ADDENDUM #4
September 21, 2020

TO: ALL Prospective Bidders
PROJECT: Contract 75 A.2-Tertiary Process Equipment:
Perforated Plate Screen
BID REFERENCE #: 89000-002.0
BID OPENING DATE/TIME: September 29, 2020 at 3:30 p.m. Local Time

REVISED SHEET NO. IFB-S-H1
REVISED SHEET NO. IFB-S-PE2

**CONTRACT 75 A.2-TERTIARY PROCESS
EQUIPMENT: PERFORATED PLATE
SCREEN**

SHEET NO.
IFB-S-H1
 1 of 6

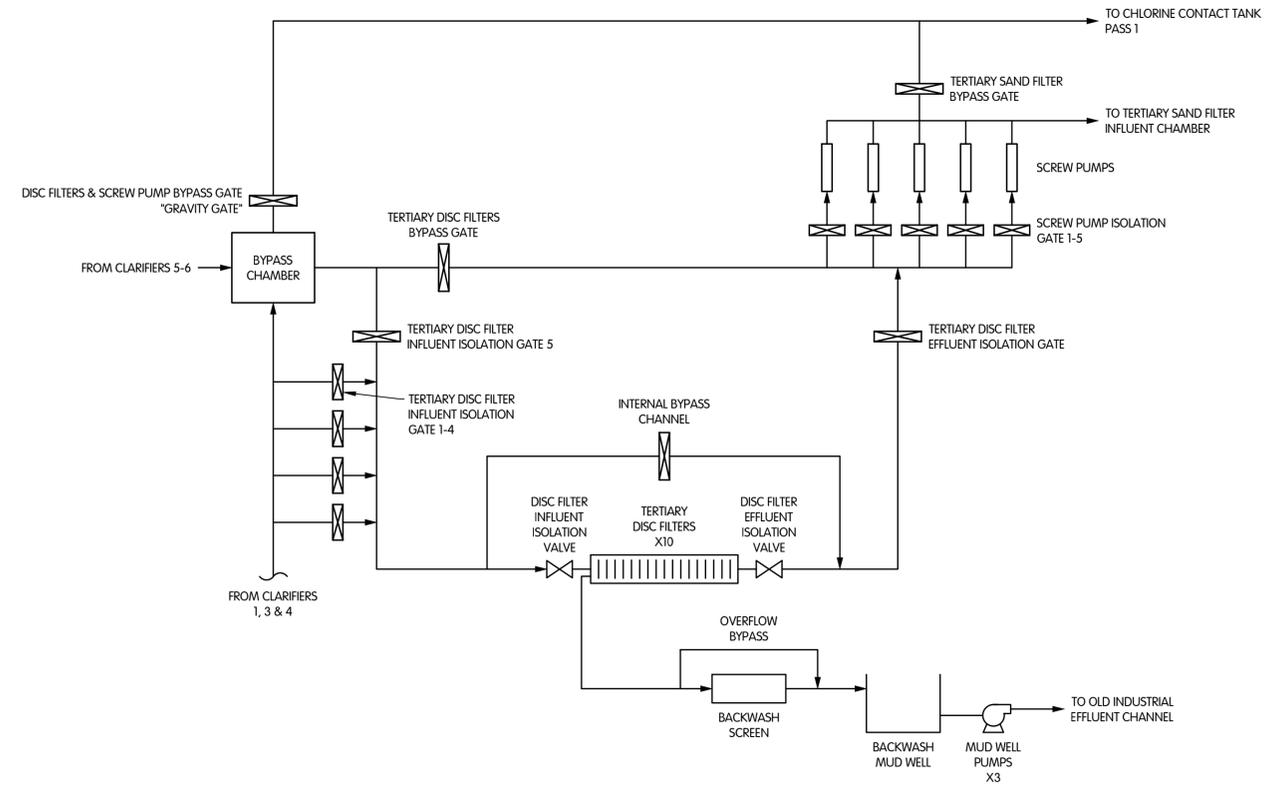
<i>Parameter</i>	<i>Unit</i>	<i>Value</i>
<i>Rated Peak Flow per Screen*:</i>	<i>GPM</i>	<i>1,400</i>
<i>Downstream Liquid Level at Peak Flow:</i>	<i>feet</i>	<i>0.86</i>
<i>Maximum Head Loss At Peak Flow:</i>		
<i>Clean Screen:</i>	<i>inches</i>	<i>30.0</i>
<i>30% Blinding</i>	<i>inches</i>	<i>42.0</i>
<i>Minimum Screen Capture Rate (SCR):</i>	<i>%</i>	<i>85</i>
<i>Maximum upstream water level</i>	<i>ft</i>	<i>757.50</i>

Elevation of bottom of screen shall be set to suit hydraulics.

**Screen will see a higher peak flow than 1,400 gpm. An upstream overflow is provided to divert excess flow around the screen.
 ”*

SHEET NO.
 IFB-S-PE2

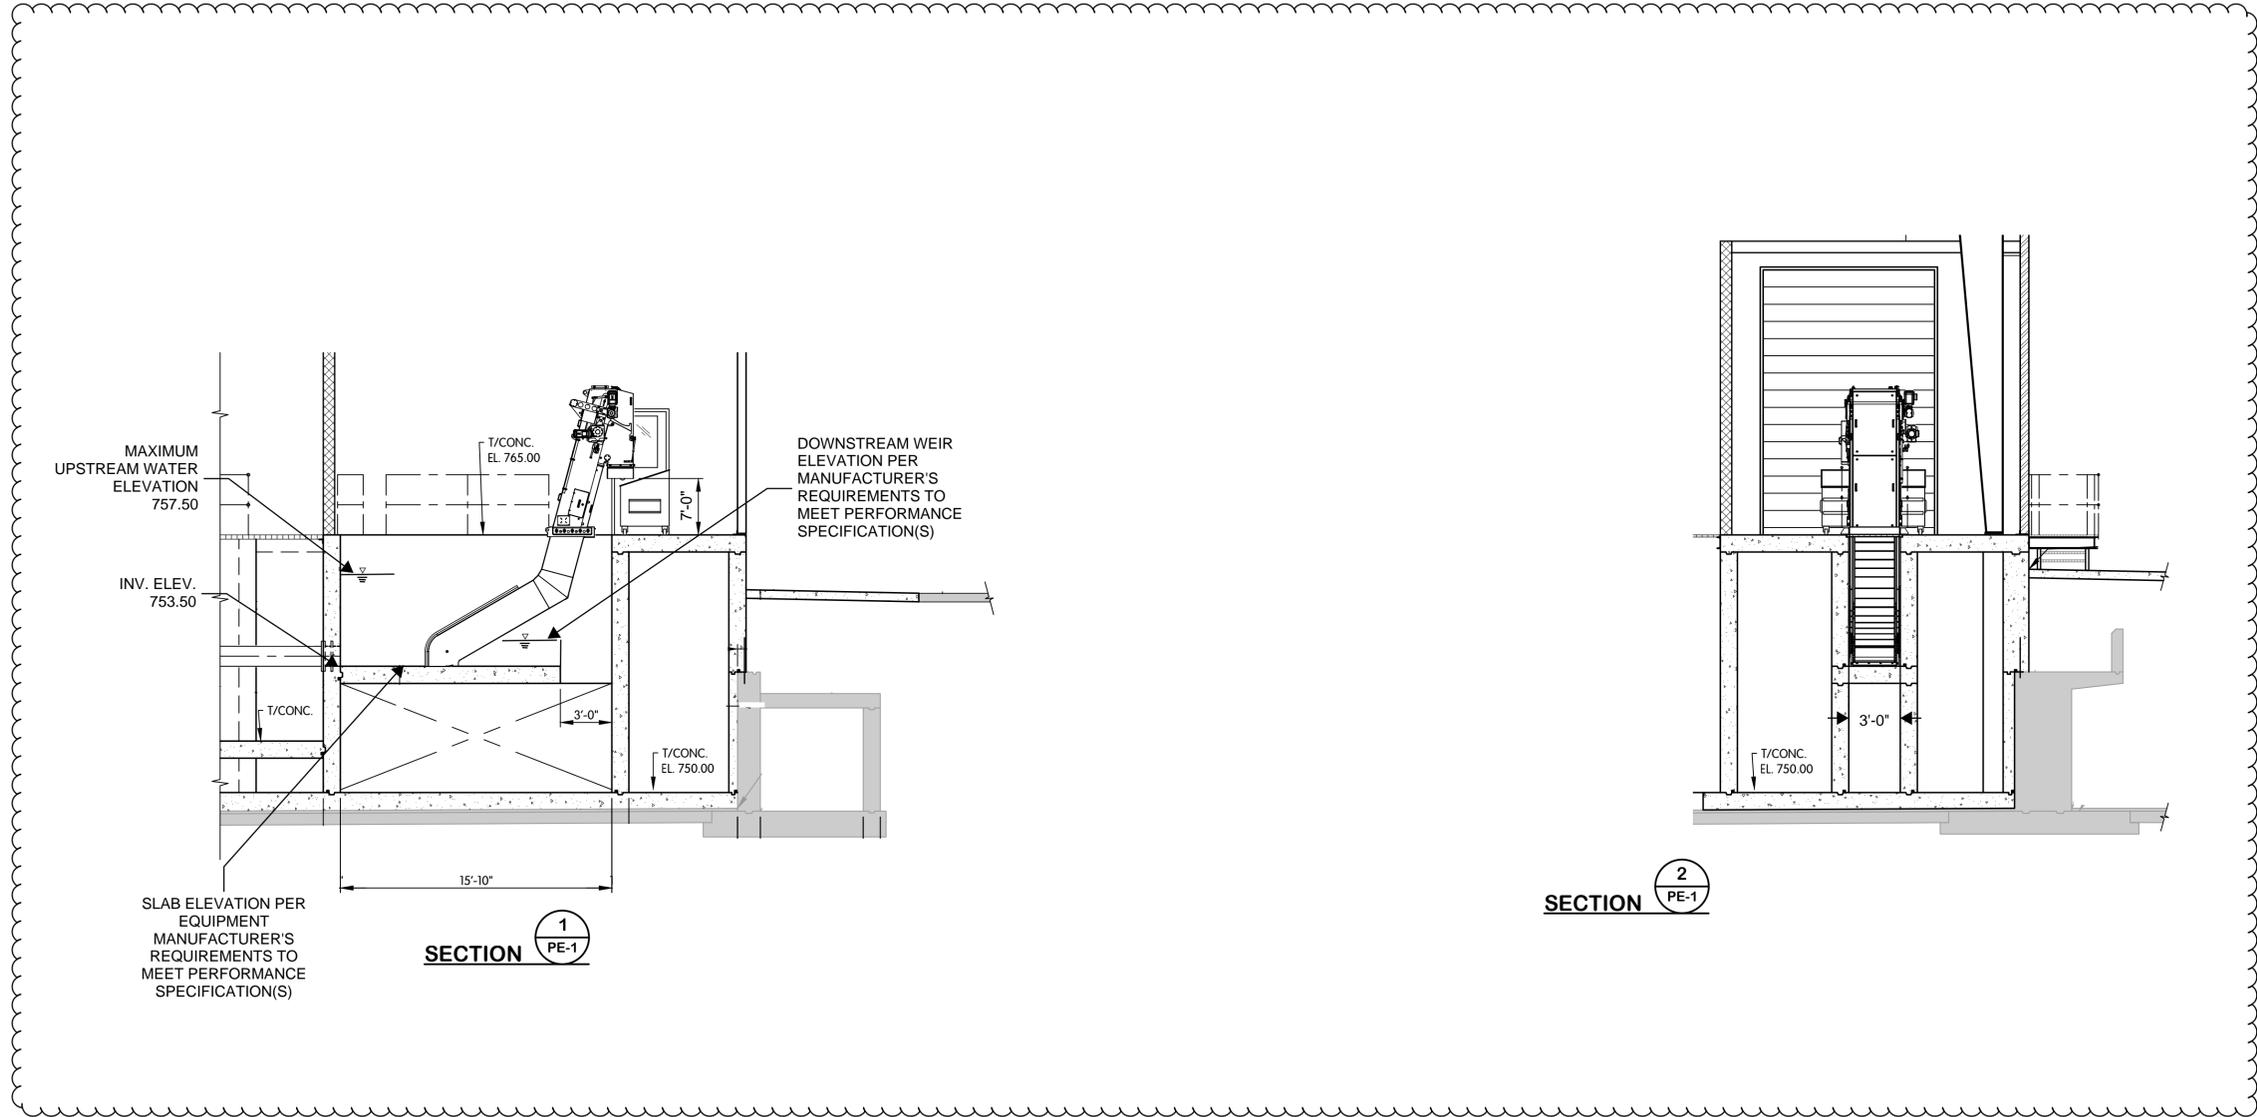
<i>System Criteria</i>	<i>Value or Description</i>
<i>Channel Width:</i>	<i>36 inches</i>
<i>Screen Panel Perforation Diameter:</i>	<i>2 mm</i>
<i>Screen Inclination:</i>	<i>30 degrees or 30/70° multi-angle design</i>
<i>Top of Channel Elevation:</i>	<i>765.00 ft</i>
<i>Screenings Discharge Elevation:</i>	<i>772.00 ft</i>
<i>Spray Water Flow, Pressure, minimum:</i>	<i>15 GPM @ 45 psi</i>
<i>Filter Panel Speed:</i>	<i>7 to 23 fpm</i>
<i>”</i>
